# Alcatraz Embarkation Site

DRB/WDAC DESIGN ADDENDUM  
JANUARY 22, 2018

BCDC Questions
WDAC Questions

## seating feature

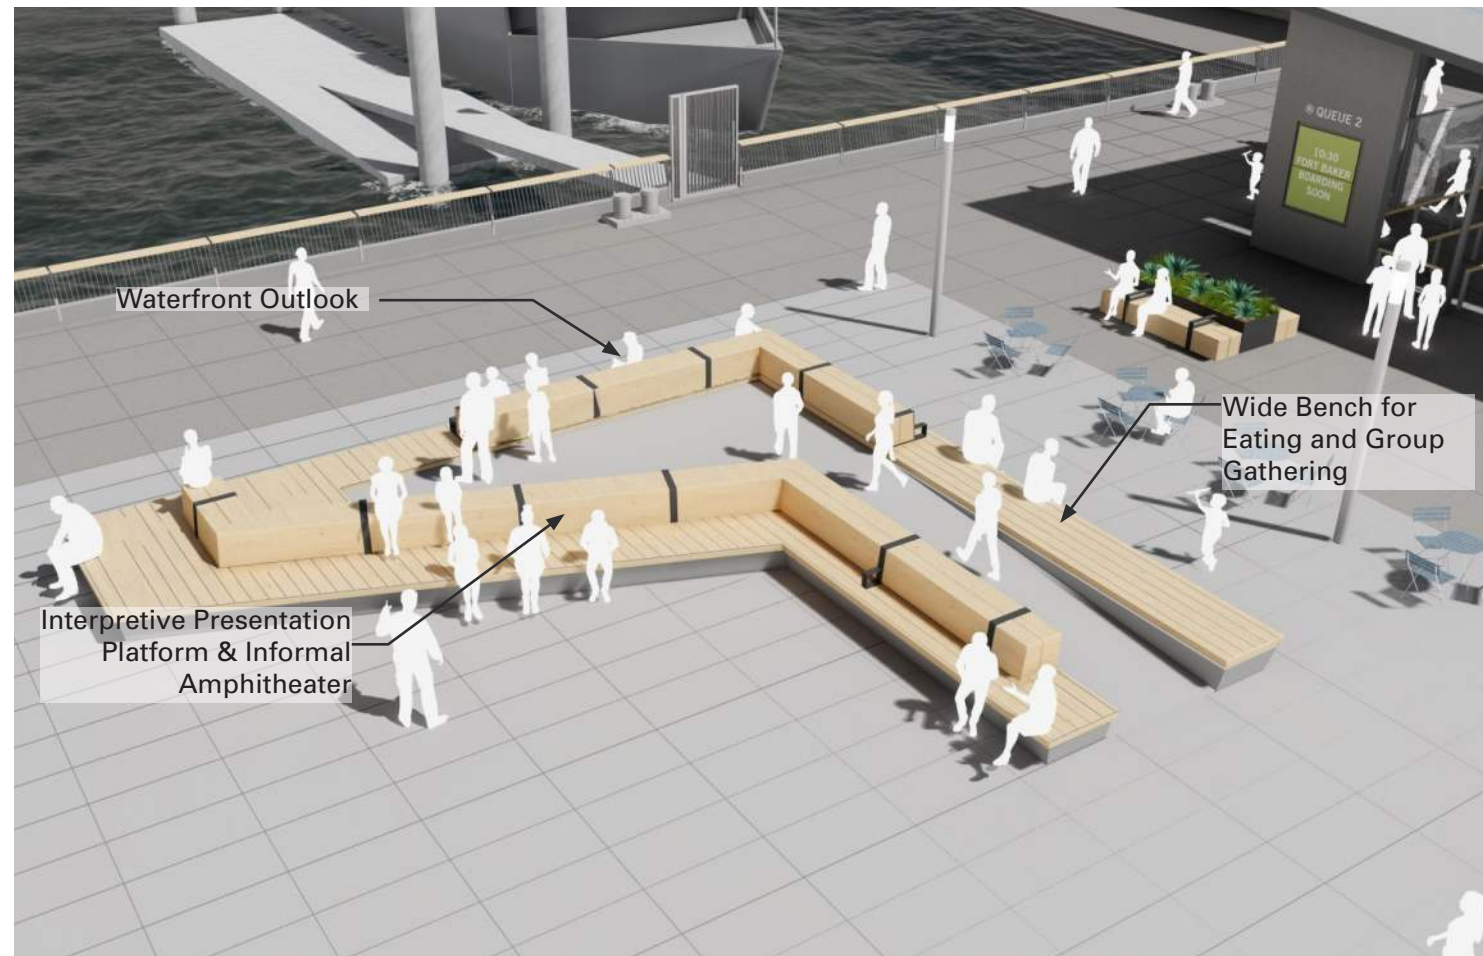
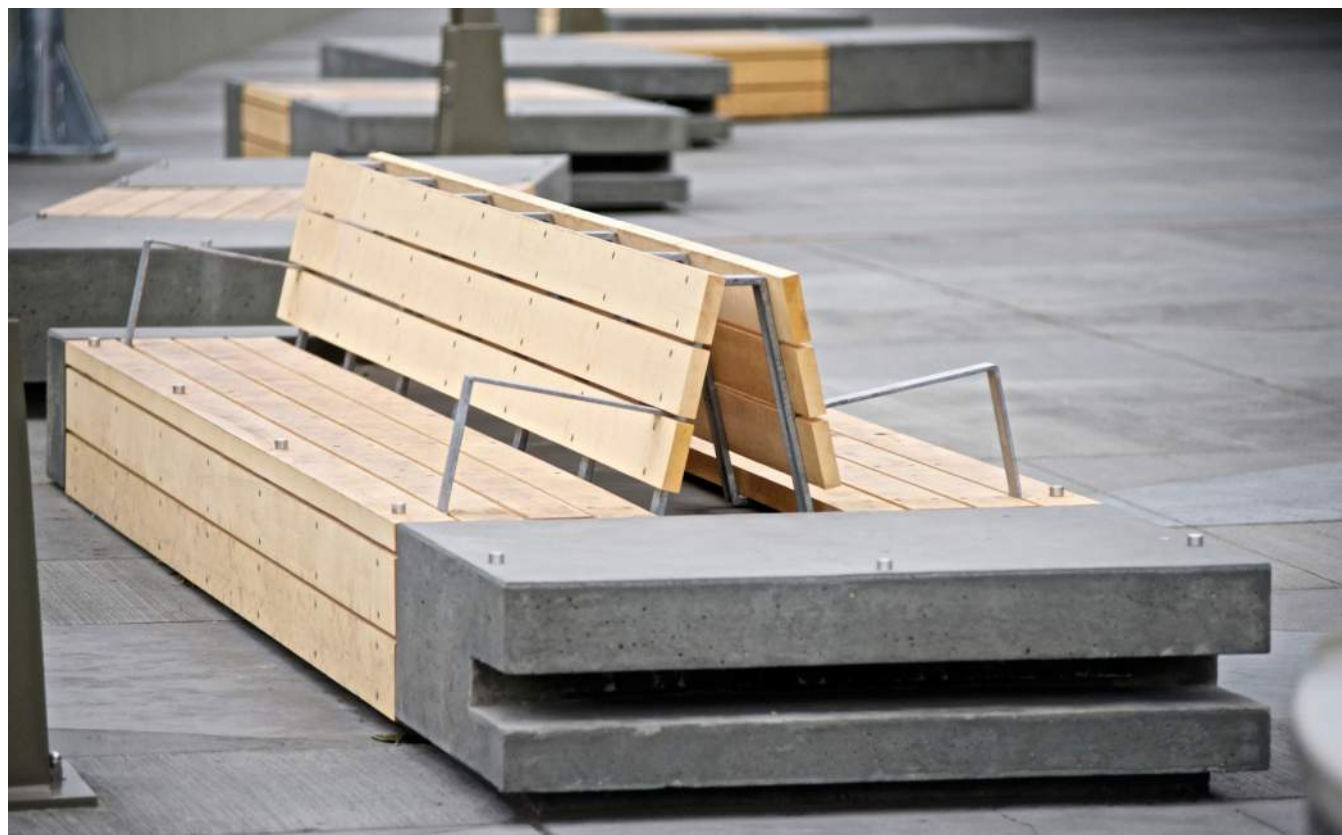
9	Improve the signage and wayfinding to easily direct the public to the location from the outside of the site and to the ticket booth once they arrive.	9, 10	
9	Appreciated the consistency of aesthetic in roof forms and furnishings.		
10	The NPS icon is obscure. Enhance the signage but incorporate it in a way that does not detract from the architecture.	10	
10	Roof forms are successful with the pier sheds, views and materials of Alcatraz.		
11	Include plantings to begin the story and set up a distinct experience as the gateway to Alcatraz - something that will tie thematically to make it richer and layered as opposed to the current civic waiting zone.	27	
11	Would like to see views of the project from the water.	16	
12	Share more with the joint Board about what is envisioned as part of the interpretive story in addition to the panels.	6, 7	
12	Suspect of the "bar" seating as it feels forced. Consider two-sided seating.	25

21	Add more seating to the larger piece facing the water.	25, 26	
21	Entry bench could be multi-directional.	22, 25, 26	
22	Consider additional seating in the space adjacent to the café while still maintaining the openness for circulation.	26	
22	Is there an opportunity for more seating in front of the café?	21, 26	
23	Consider another material besides concrete for the shear walls.	12-16	Narrative
23	Tilt of the roofs is great, success will be in the details.	17	
24	Include views from different positions to help the Board understand the most optimal place for the shear walls.	12, 14, 15	
24	Are there other ways to accomplish the job of the shear walls such as bracing	12-16	Narrative
25	The opening to this location is small. Include views from other positions along the Embarcadero to help the Board see the important opportunity of the leading edge (of the objects in the plaza) to improve wayfinding and a sense of arrival.	21, 22

The larger seating feature on the North side of the central Civic Plaza serves multiple functions for visitor:

1. An informal amphitheater and stage face the interior of the plaza and provide an area for groups to gather to enjoy presentations by interpretive staff about Alcatraz Island and the Port of San Francisco.
2. A backed bench and wide backless bench on the Cafe facing side provide areas to gather in small groups and provide surfaces for eating and resting.
3. An accessible sloped walk allows access to a central platform that is 20" above the plaza surface allowing for open views over the crowds and out on to the Bay. On the waterfront facing side high backed seating is provided to allow an outlook for enjoying the views of the San Francisco Bay.

The maximum height of the feature is 36" at the high backed bench. This allows for uninterrupted views from the street and plaza over the seating feature to the view of the Bay.

## seating and bicycle parking

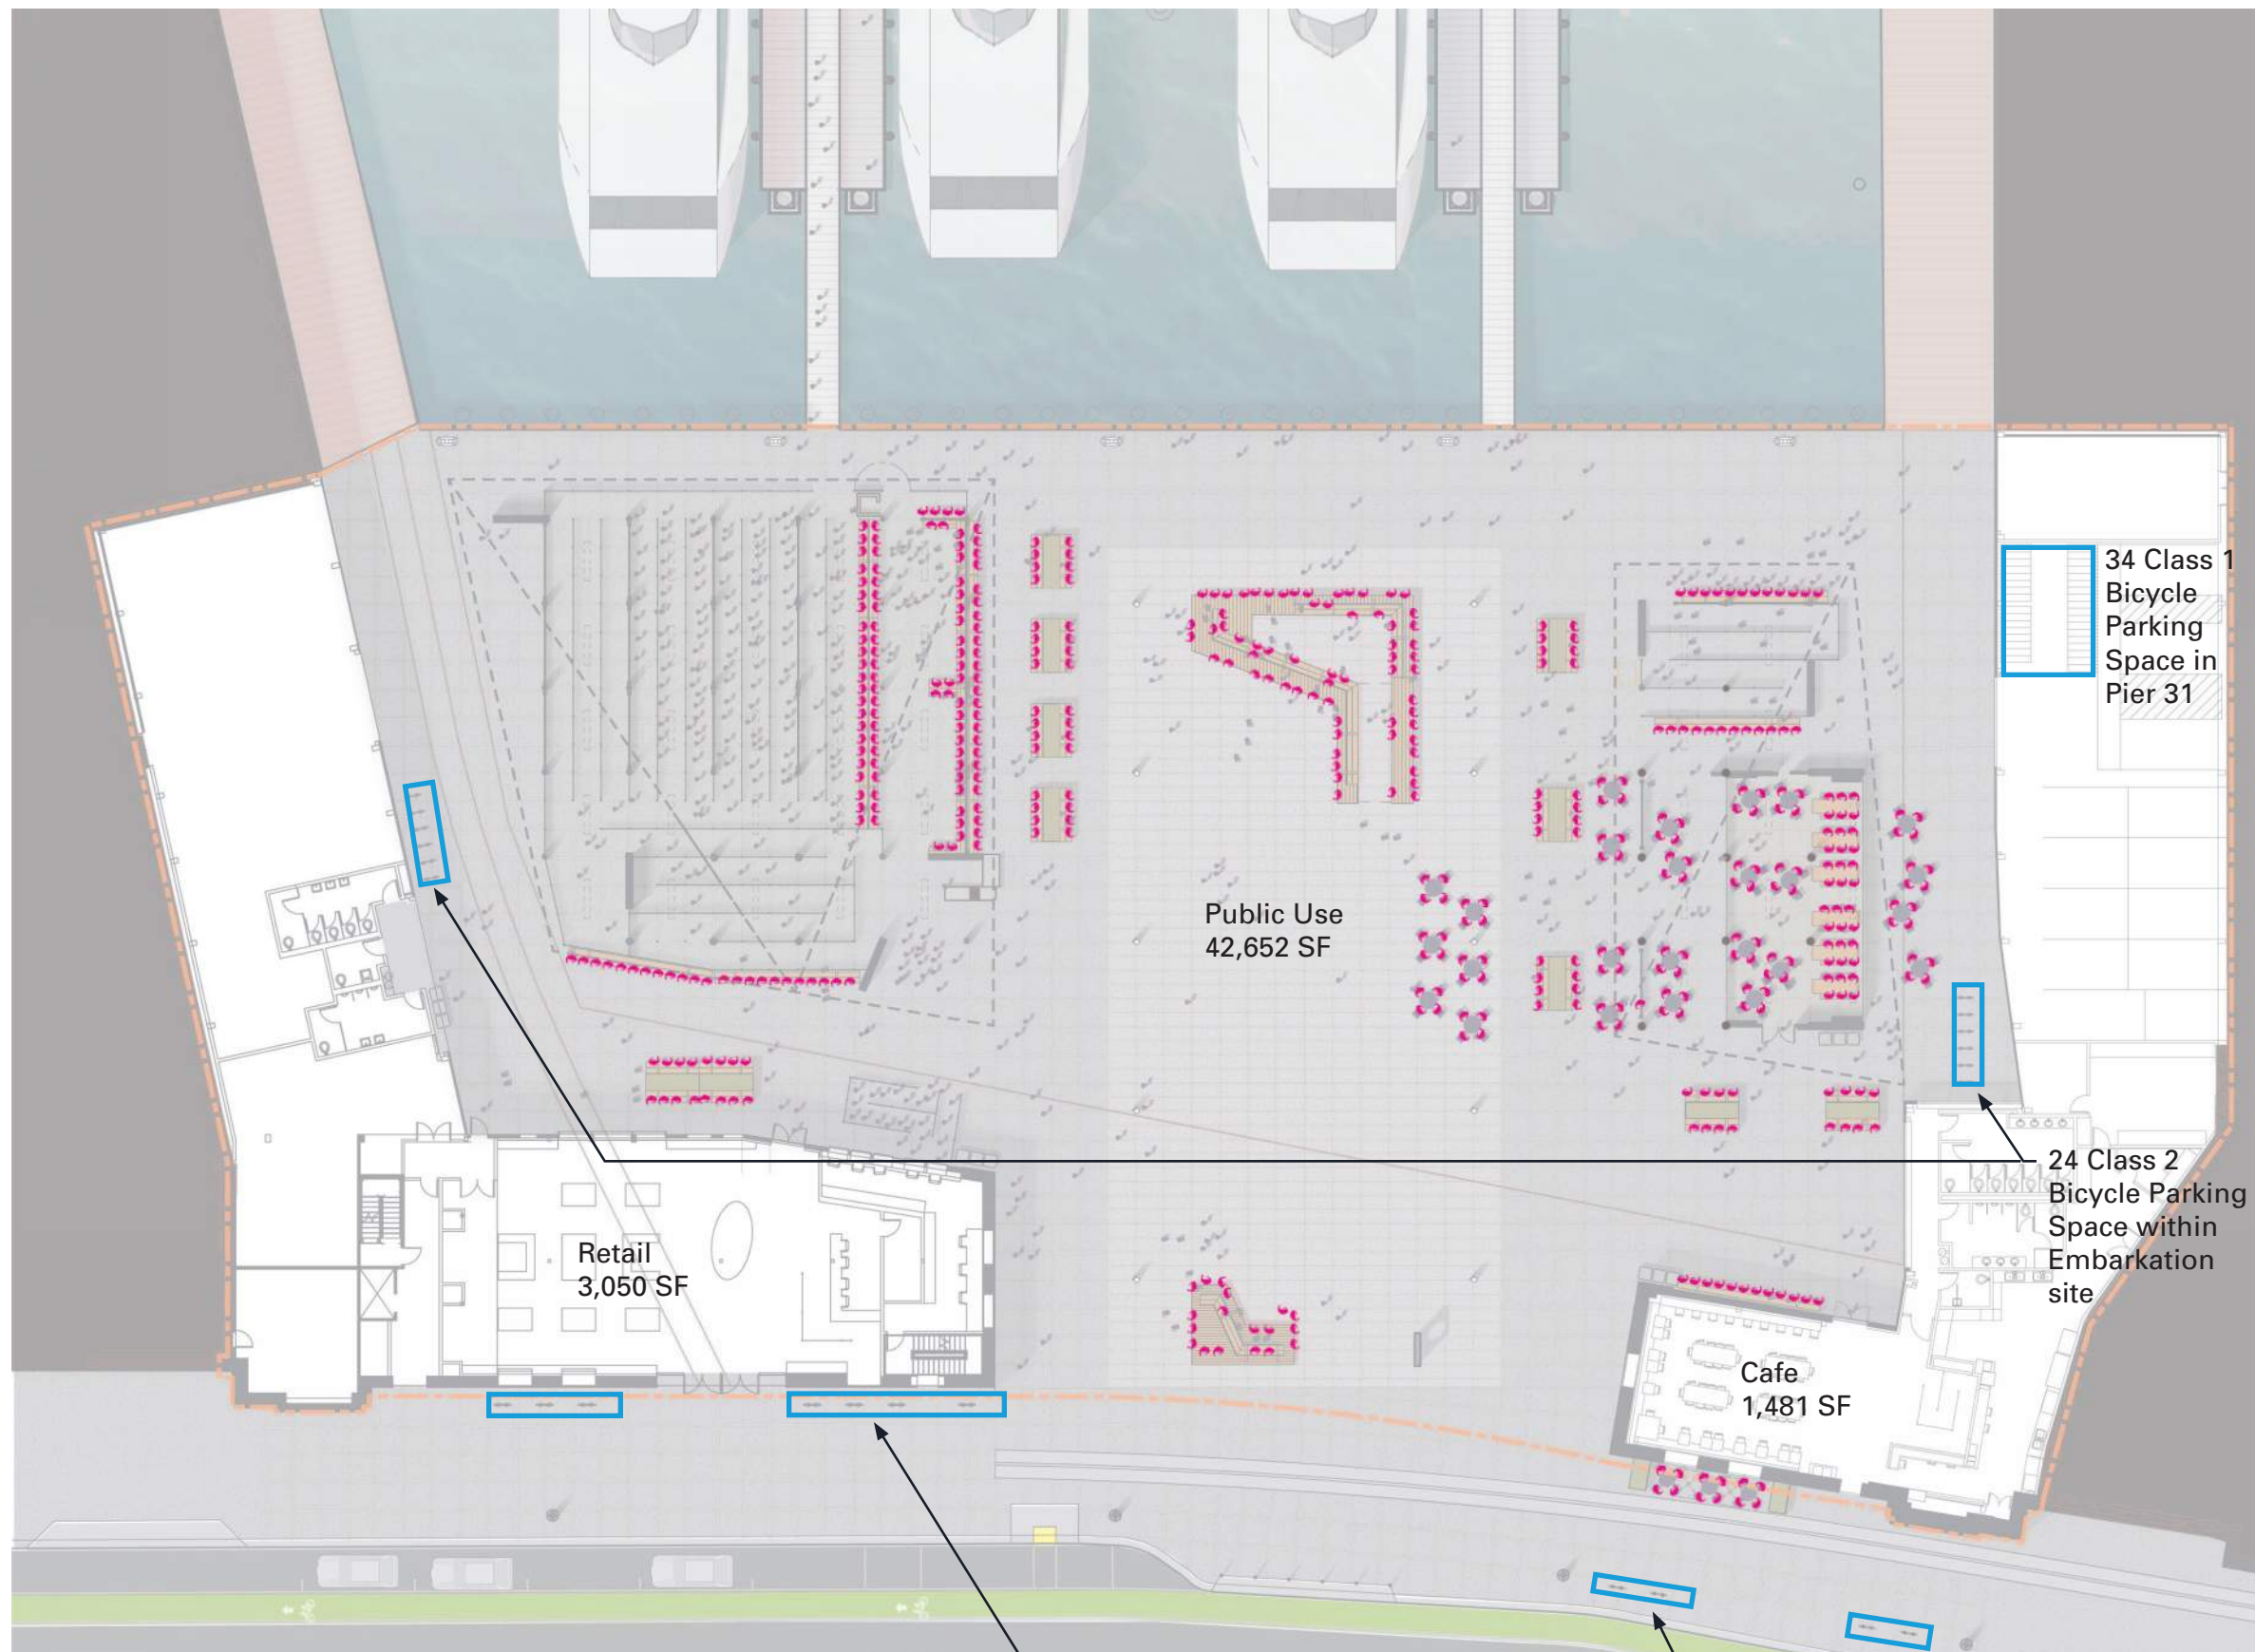
5	Although the design presents a strong sense of arrival for visitors, the wayfinding does not appear adequate. People may need more identity to the purpose of the site. Please put more thought into signage and wayfinding including directing people to the ticket booth.	9, 10	
6	Increase the number of bicycle parking spaces, perhaps including some in the open space, or more directly connected to the plaza.	26	
6	Concern that access to the bike parking will not be understood.	9, 26	
7	Include additional seating in the central zone.	26	
7	Concern that the interpretation will not feel accessible to children and foreign visitors.	6, 7	
8	Include things for children to do while waiting for the ferry, expand the ways the interpretive amenities can be experience, beyond the proposed panels.	6, 7	
8	Concern over the void of planting. May want to use planting to make the space feel less civic and more tied to Alcatraz.	27

Maximum Site Visitors Per ORCA  
space planning model: 1000  
# of visitor to Island: 600  
# of visitors from Island: 400

Quantity of Seating:  
492 lf of Bench Seating  
= 325 Bench Seats (18")  
222 lf of loose seating  
= 148 Loose Seats (18")  
Total LF of Seating = 714 LF  
Total Seats = 473 (53% of max  
visitors)

SF General Plan guidelines  
for seating in urban plazas is  
recommended to be: "One linear foot  
of seating space per each linear foot  
of plaza perimeter. One half of seating  
to consist of benches."

Plaza Perimeter = 800 LF  
Total LF of Seating = 714 LF  
Seating Provided:  
89% of Plaza Perimeter  
68% of Seating is Benches

Bicycle Parking Recommendations  
per SFMTA Bicycle Parking  
Guidelines:

Retail 3,050 SF:  
1 C1 per 7,500 SF = 1 C1  
1 C2 per 2,500 SF (min 2) = 2 C2

Restaurants 1,482 SF:  
1 C1 per 7,500 SF = 1 C1  
1 C2 per 750 SF (min 2) = 2 C2

Public Uses: 42,652 SF:  
1 C1 per 5,000 SF (min 2) = 9 C1  
1 C2 per 2,500 SF (min 2) = 17 C2

Total Bike Parking Requirements:  
C1 (Protected) = 11  
C2 (Accessible) = 21

Bike Parking Provided:  
C1 (Protected) = 34  
C2 (Accessible) = 52

28 Class 2  
Bicycle Parking  
Space at  
Embarcadero  
Sidewalk
